Date: August 14, 2019

From: Katie Cote, Planning Consultant
Lucy Sloman, Land Development Manager
Doug Schlepp, Engineering Consultant
Stacey Rush, DSD Engineer

Subject: Briefing Response Memo for Evergreen Ford Lincoln Dealership
Site Development Permit: SDP19-00001; PRJ12-00003

Revised design with additional vertical columns (L: Phase One; R: Phase Two)

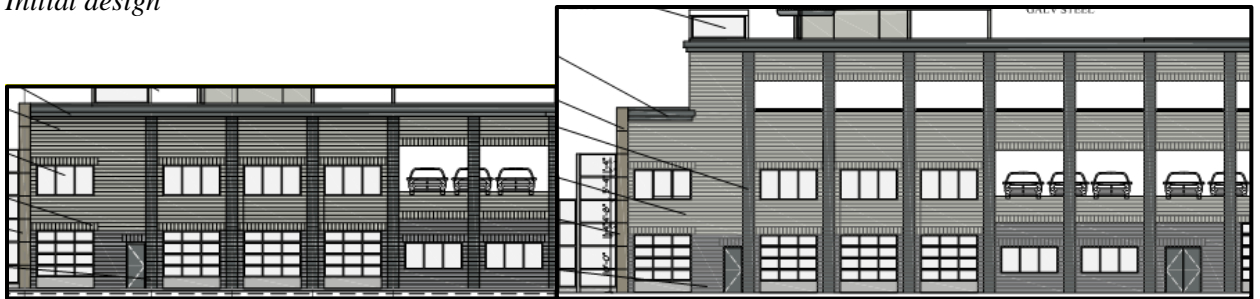
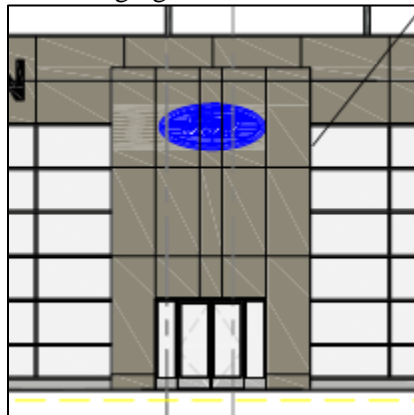
- Increasing vertical emphasis by adding additional vertical columns at the parking garage structure

The vertical columns have been increased in number and depth to provide a stronger vertical emphasize on the parking structure to address the concerns of both scape of the structured parking openings and to provide a stronger vertical emphasis to the project.

Revised design of Ford entry element (L), to be composed of “Pietra Serena” limestone panel (R)

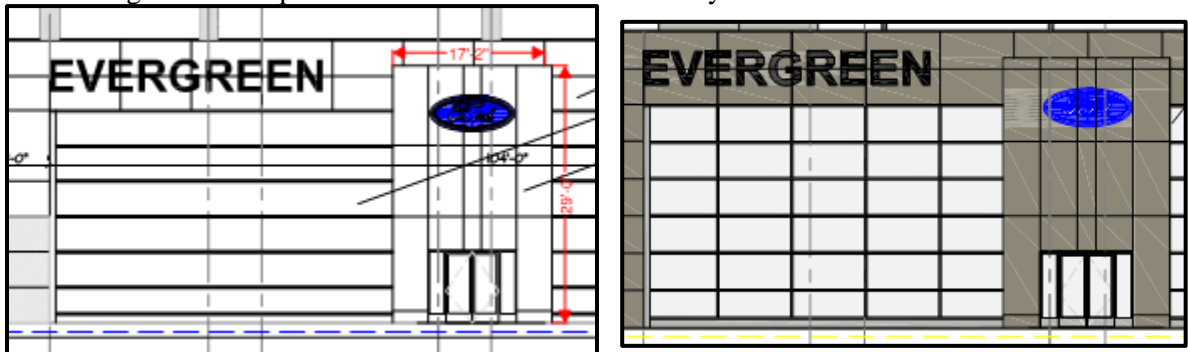
- Changing the materials of the Ford entry element from metal panels to stone

The exterior elevation been revised, removing the ACM and replacing it with a Limestone/synthetic stone wall panel approved by Ford. The technology of the early 20th century did not allow for the type of windows shown in the elevations. To bring the project closer to the Northwest Revival style vertical mullions caps were added to the ford display.

R: Revised design with greater vertical emphasis and shadow lines)

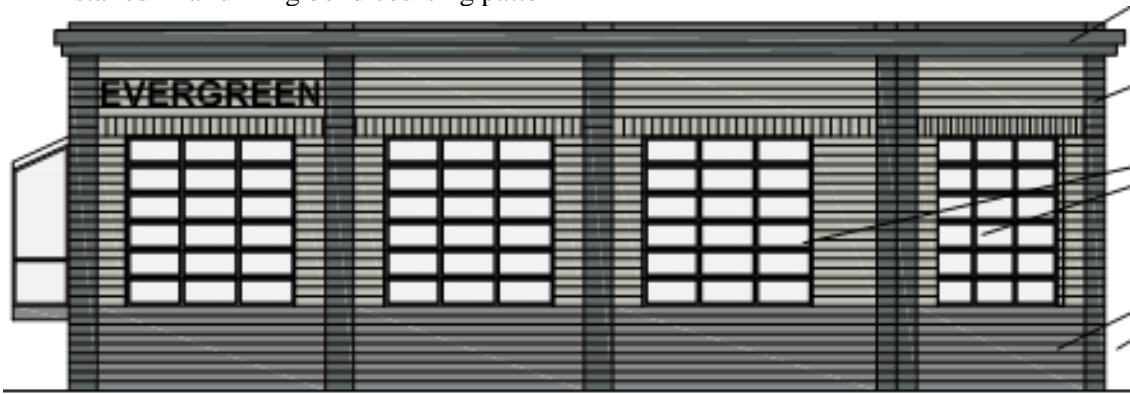
- Adding vertical emphasis and shadow lines to Ford entry brand wall windows

Franchise Requirement for the Ford Brandwall/display area. We have added vertical mullions as noted above as shown to reduce the horizontal emphasis of this area.

Revised pavilion design showing glazed masonry material

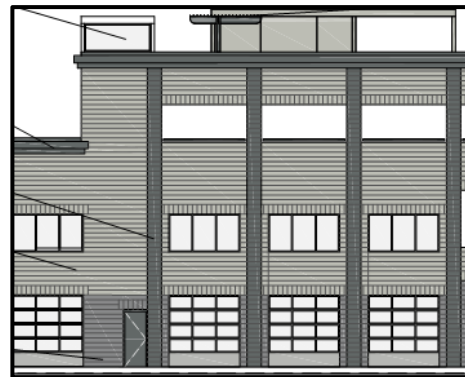
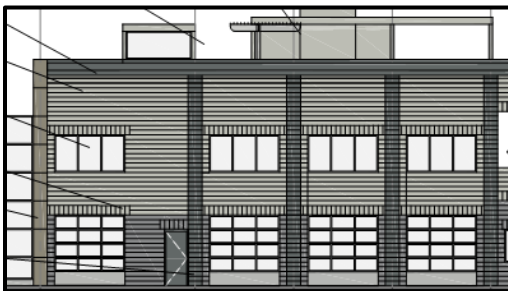
- Changing the materials of the garage and pavilion structures to a glazed masonry material installed in a running bond coursing pattern

Revised design of Lincoln “jewel box” showing white bezel composed of metal panels

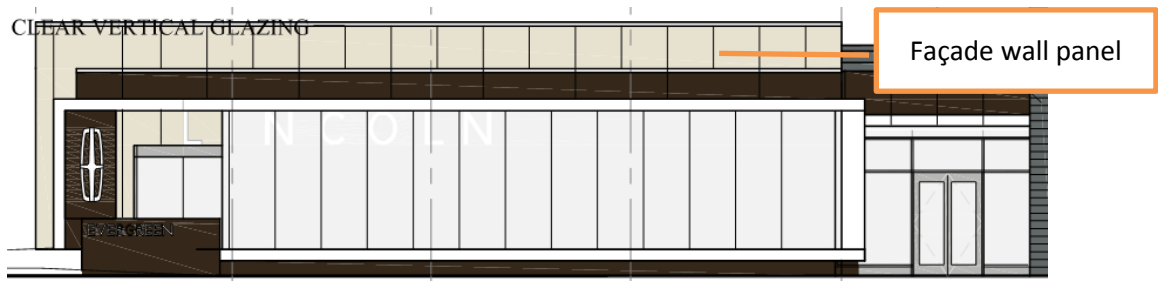
The Lincoln Dealership has an architectural style dictated by franchise brand requirements. The design seeks a luxurious architectural look inspired by the midcentury modern aesthetic, including a low-ceilinged “jewel box” display area at the primary street frontage. This display feature is framed by white bezel detailing comprised of metal panels. Metal is listed as an inappropriate wall material in the Northwest Revival style. However, the use of these metal panels is very minimal in relation to the overall building, and their finish does not have a metallic appearance. Similar to a cast iron painted detail that might have appeared historically on this type of building, staff suggests the Lincoln storefront’s minimal use of painted metal as an accent material is acceptable. Also, while tile is not an allowed wall material in the Northwest Revival style, staff has determined that the use of porcelain panels that effect a masonry appearance is substantially compliant, per the condition below.

Revised design of Lincoln storefront featuring vertical glazing

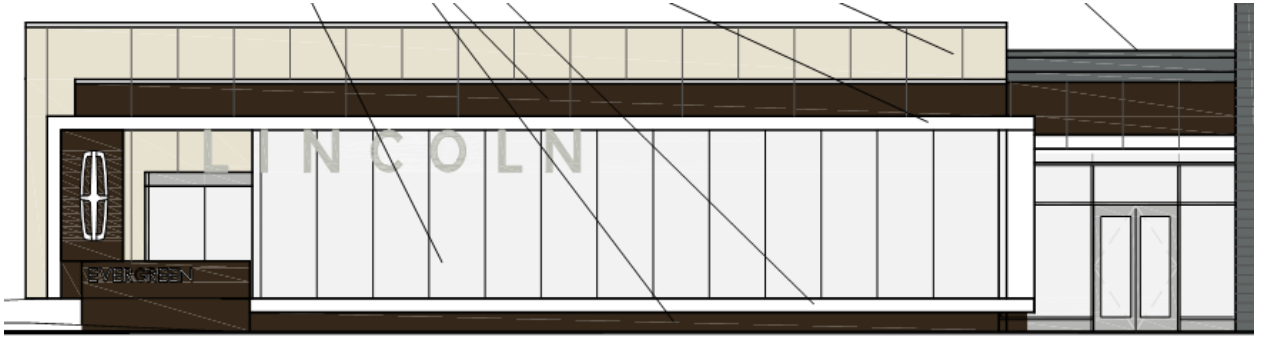
- ii. Materials | Windows: The storefront windows lack depth and shadow.

The Lincoln Dealership “jewel box” features vertical glazing that lacks the depth and shadow of deep-set, individually spaced “punched windows” appropriate to the NW Revival style. Though it appears additional vertical definition has been added to the Lincoln storefront, additional window details are needed to determine whether the windows exhibit appropriate depth and shadow lines. This will be confirmed with building permit review.

While the glass jewel box of the Lincoln design uses butt glazing at the face the strong vertical mullions show through the glazing façade. The bezel head and sill, both which is 2'-0" deep provides a strong horizontal shadow line on the northwest elevation. On the northeast elevation (230th street) the window wall has been broken up into smaller sections and are recessed 8" to provide shadow.

Revised design of parking garage structure, Phase One

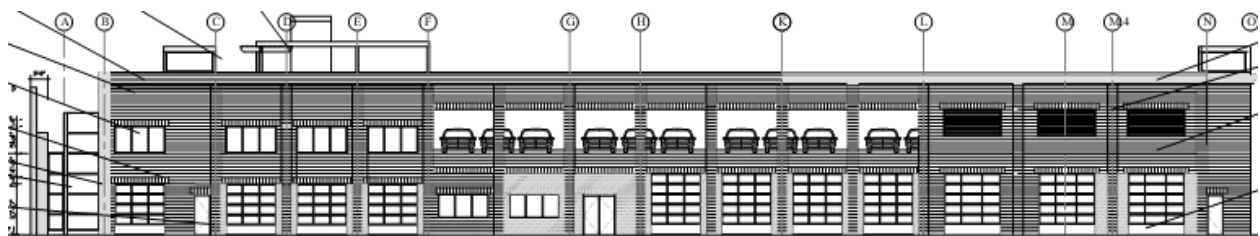
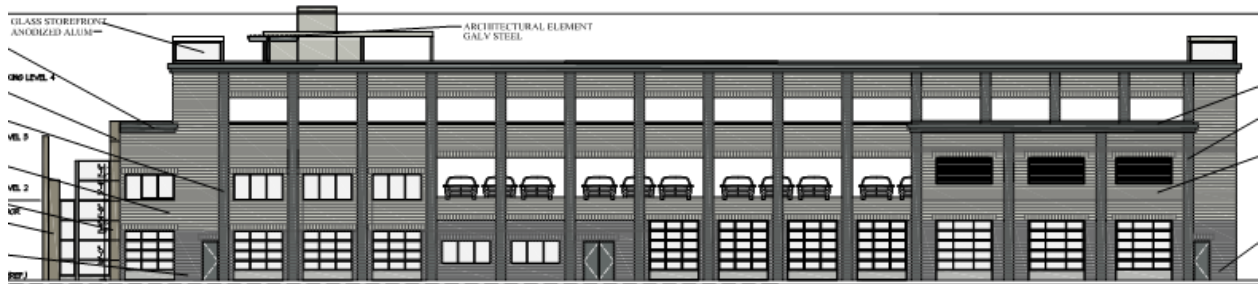
Staff:
 The applicant has added additional vertical columns consistently along the parking structure facades to emphasize verticality. The primary wall material has been changed from concrete to a

Location of trellis (yellow) near pavilion

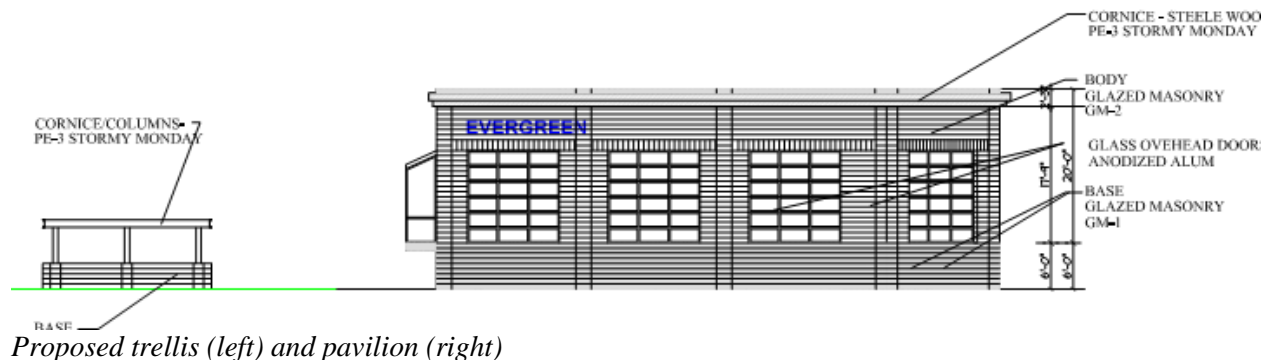
Building frontage requirements apply to the portion of the building along the property line abutting E. Lake Sammamish Parkway. Per CIDDS Chapter 11.3.G, the building must fill at least 60% of the frontage. There is a deficit of 16 feet of building frontage, which the applicant has filled with an architectural feature – a 16 foot long trellis. This architectural feature meets the requirements of CIDDS Chapter 11.3.G; therefore, Proposed SDP Condition 13 is no longer required.

Conclusion: The applicant has provided a description of the how the pavilion will be used, has added alternative frontage consistent with CIDDS requirements, and the change in materials brings the pavilion into compliance with the Design Manual. Delete proposed SDP conditions #13 and 17.

Revised entry design showing mounded sidewalk at Lincoln Dealership storefront

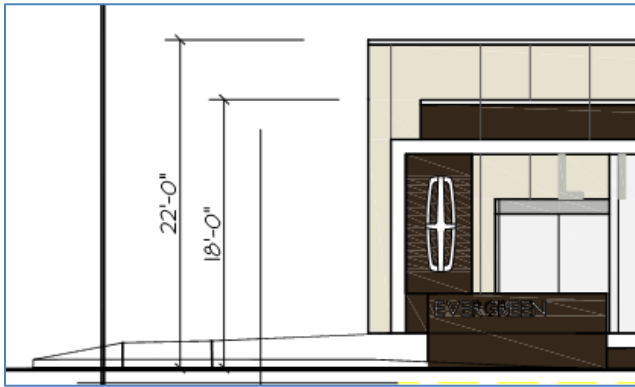
- i. **Building Edges | Entries:** The entry to the Lincoln dealership is not at-grade.

The applicant has revised its entry design to include a mounded sidewalk, which places the entry at ground level. This design element is now consistent with the Natural Context standards.

Planting plans showing shrubs, trees, and groundcover in entire 75' buffer area.

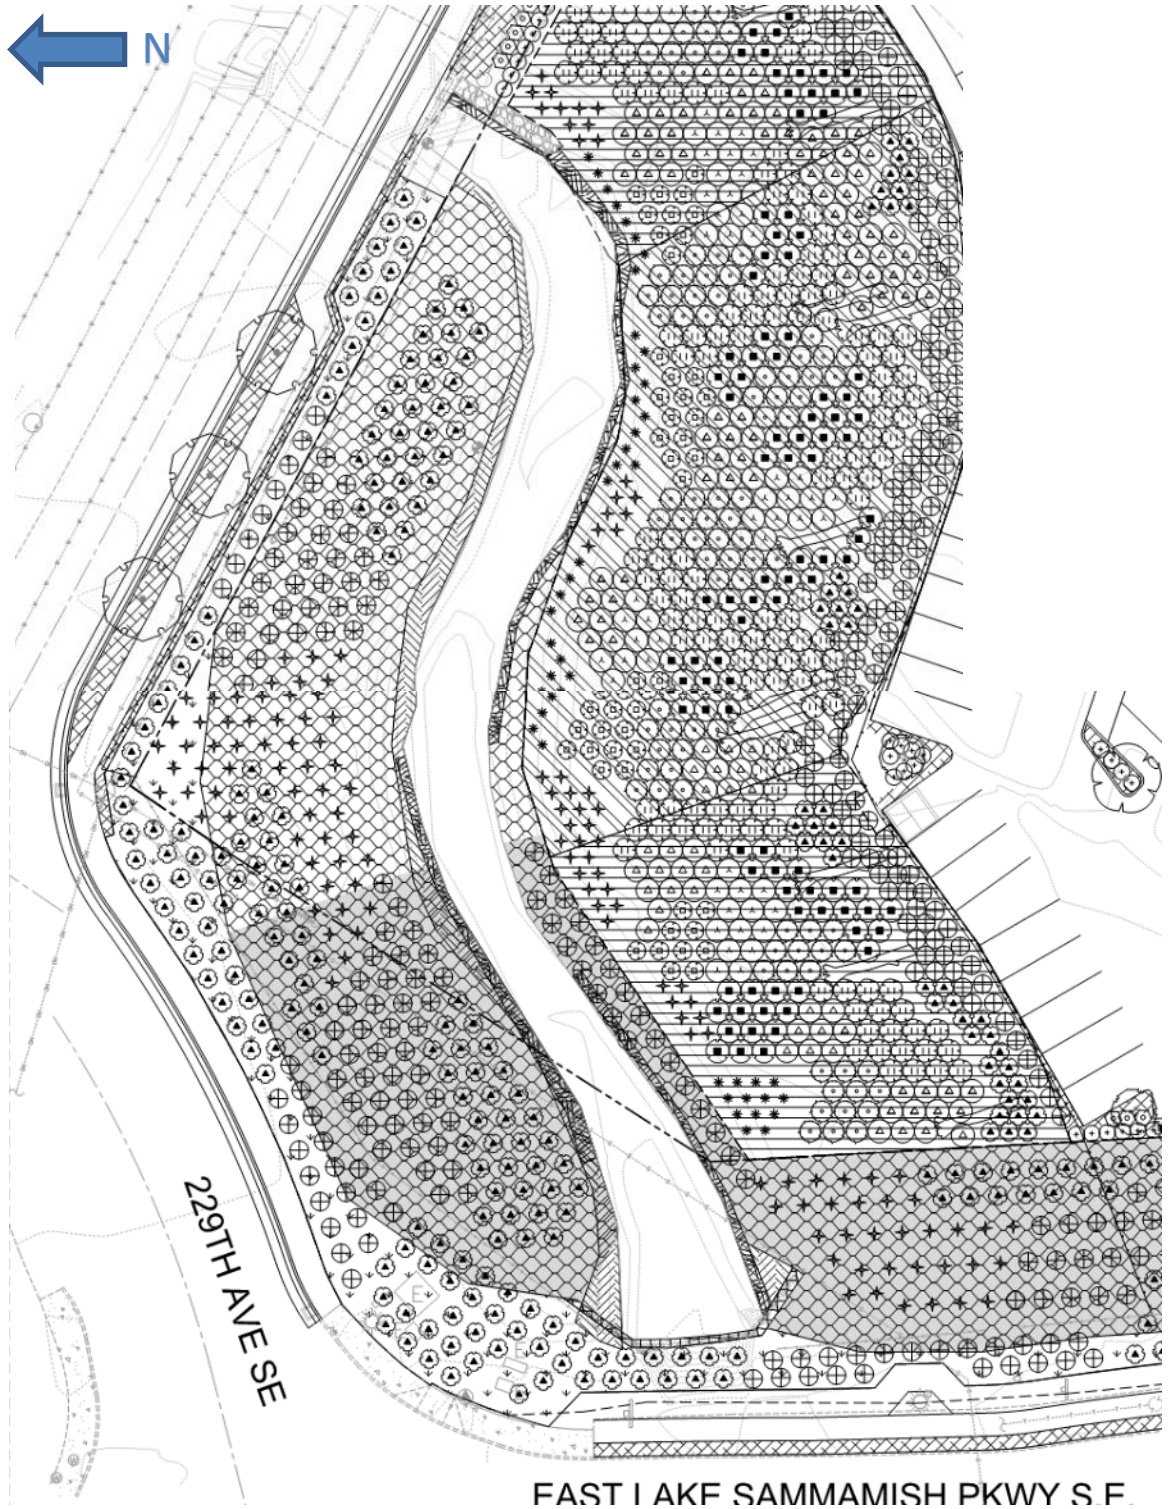
Comments from the Muckleshoot Tribe raised concern that the intrusion of the frontage improvements in the buffer should be mitigated to prevent impacts to aquatic habitat. Staff has revised SEPA Condition 5 to mitigate for the buffer impacts in the offsite right of way area. See Conclusion.

The buffer impacts caused by the frontage improvements along of the E. Lake Sammamish Parkway are mitigated through SEPA Condition 5:

To mitigate impacts associated with offsite frontage improvements within the N. Fork of Issaquah Creek buffer, all onsite and offsite buffer areas within 75' feet of the ordinary high water mark shall be mitigated with enhancements, e.g. adding large woody debris, trees, shrubs, and groundcover, spawning gravel, upsized trees, etc. These areas include both sides of the onsite stream buffer, as well as the portions planted by WSDOT offsite.

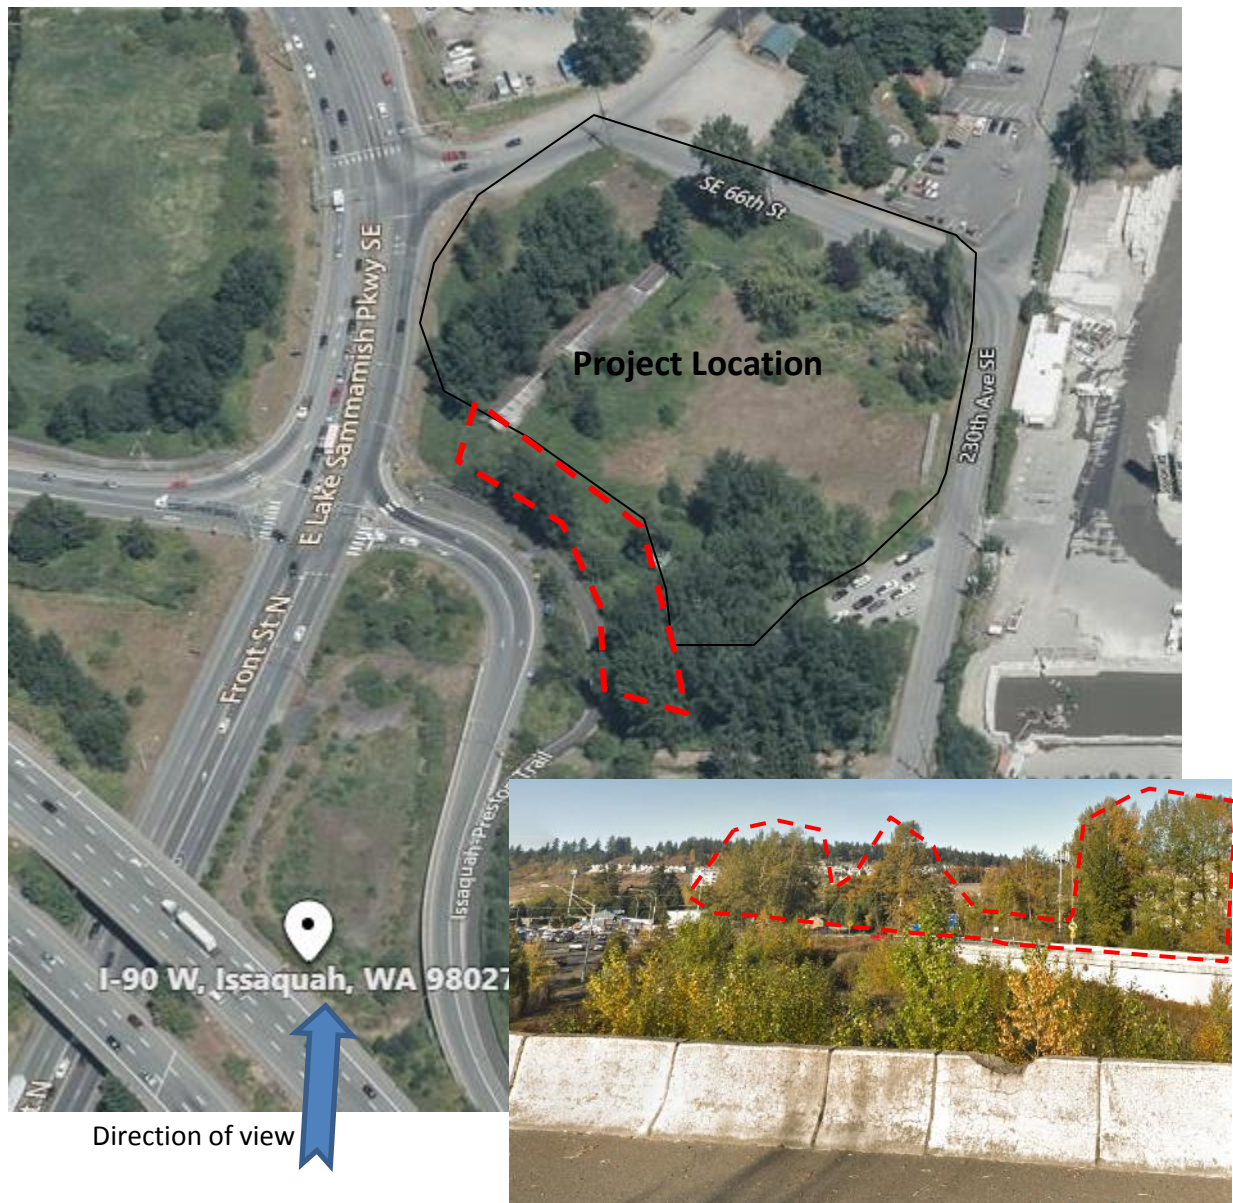
How does view analysis factor into SEPA review? What is the visibility of the project from I-90?

Views of the site itself from Interstate 90 would be partially obscured by existing landscaping in the WSDOT right of way, as shown on the graphic above.

Views of the project site from Interstate 90 will be screened by existing vegetation in the WSDOT right of way (see red dashed outlined area above and right). The image on the bottom right shows the view of the site looking north from I-90 from the approximate viewpoint of the blue arrow. The site will be very visible from the I-90 off ramp until vegetation grows in on the site or along the ditch; however, plantings both onsite and in the offsite areas adjacent to the ditch will be added during construction and though small, they will provide immediate softening of views of the site.
